PREVOST

**SAFETY
RECALL**

SR21-308

| SUBJECT: | AMERICAN SEATING COMPANY PASSENGER SEATS INSTALLATION ISSUE. ADDITION OF A SPACER AT THE FIXED SEAT WALL BRACKET | |

FIGURE 4

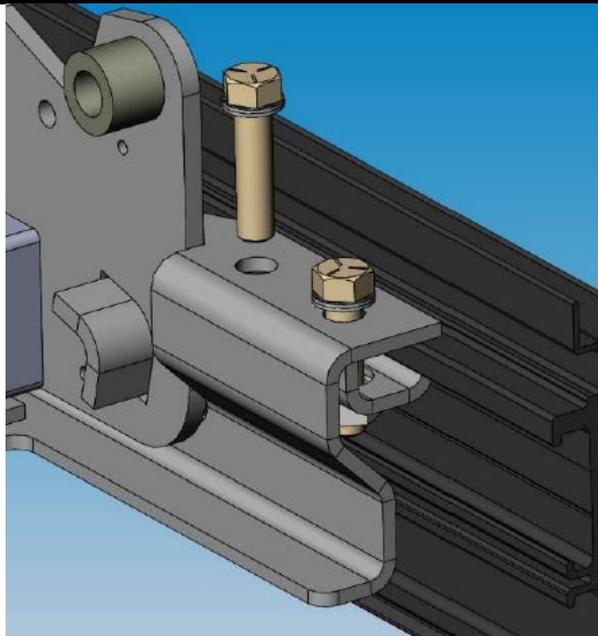
1. Loosen both bolts and remove inner bolt completely while leaving back bolt engaged into U-bracket to hold the bracket in place.

FIGURE 5

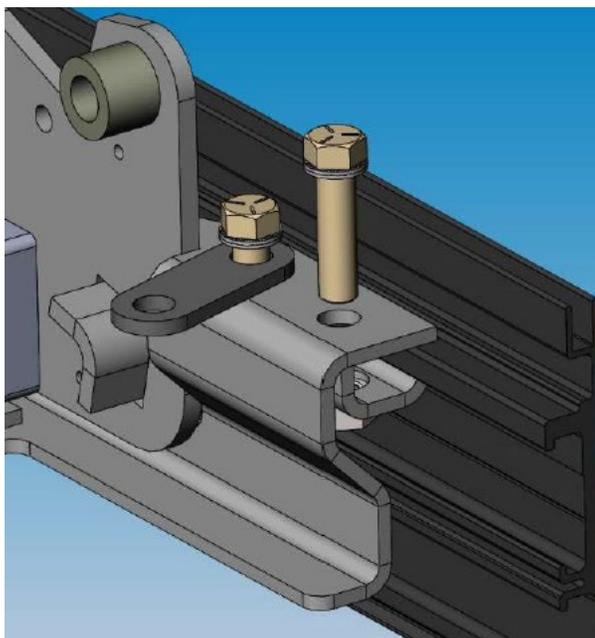
2. Remove Nord-Lok washer from bolt and place onto new fully threaded bolt. Reinsert thru the spacer and FINGER TIGHTEN into the nut of U-bracket to hold the bracket into place while removing back bolt.

FIGURE 6

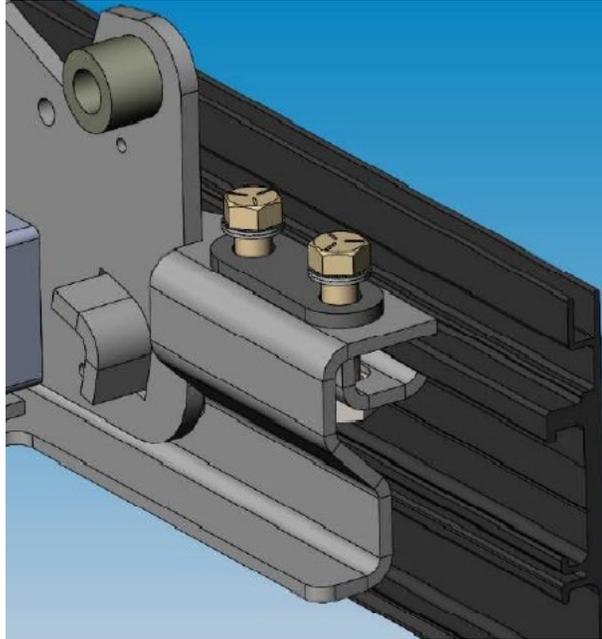
3. Remove and replace Nord-Lock washer onto new back bolt, swing spacer into position and reinsert new bolt into back position by FINGER TIGHTENING into the nut of U-bracket.

Figure 7

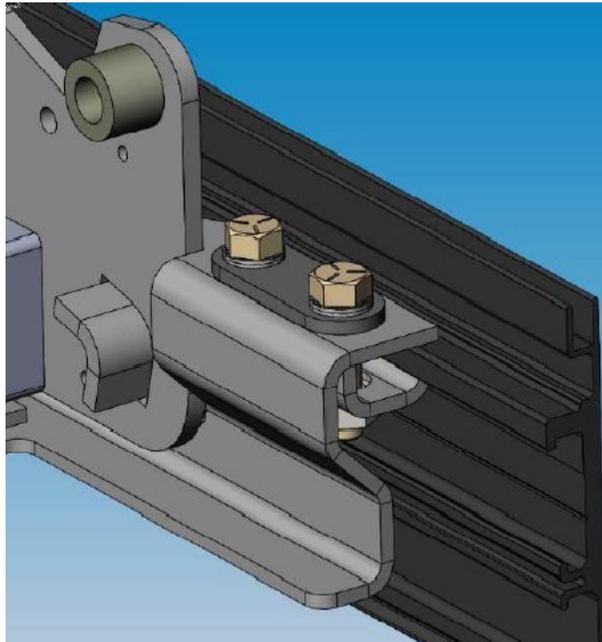
4. Tighten both bolts to Prevost torque value of **27 ft-lbs** and check bolt ends for clearance.
5. Add torque seal mark as required.
